Subject: N202310870 - Service Update Front License Plate Frame Out of Specification

Models: 2021 GMC Yukon

# Service Update N202310870 Front License Plate Frame Out of Specification

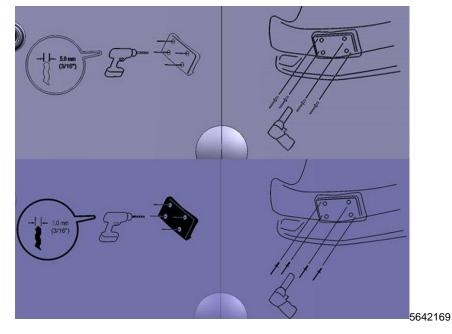
Condition	Certain 2021 model year GMC Yukon vehicles may have a standoff flange on the front license plate mounting bracket that is too long and may interfere with the front fascia when being installed. The license plate bracket can be installed but bows away from the front fascia and in some cases, the front license
	plate bracket cannot be installed.
Correction	Dealers are to install the front license plate bracket.

1. Remove the incorrect front license plate bracket if already installed.

2. Install the new front license plate bracket using the diagram above.
